Bulletin No.: PIT6077
Published date: 10/24/2023

PIT6077 Exhaust Tailpipe Tips Misaligned When Comparing Left To Right Sides

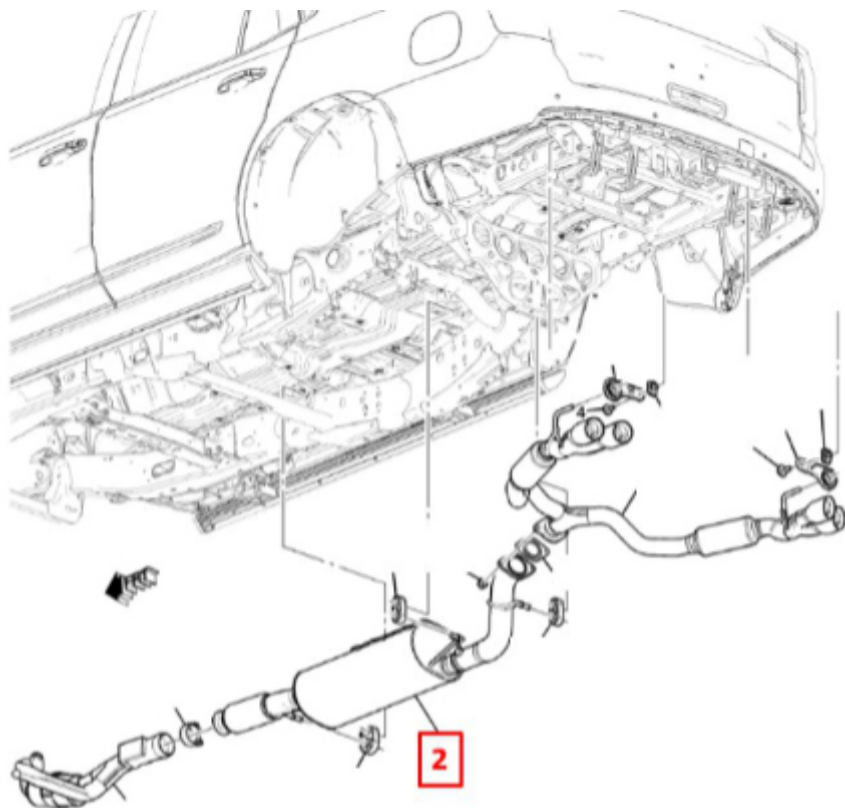
Involved Region or Country	North America
Condition	Some customers may comment that the exhaust tailpipe tips are misaligned. The left side exhaust tip will protrude further out from the rear bumper fascia when compared to the right side exhaust tip, as shown below (1).
Cause	The cause of this concern, is a manufacturing variation when the S-pipe is welded to the muffler.

Do Not replace the tailpipe assembly.

To correct this concern, replace the muffler, shown below (2).
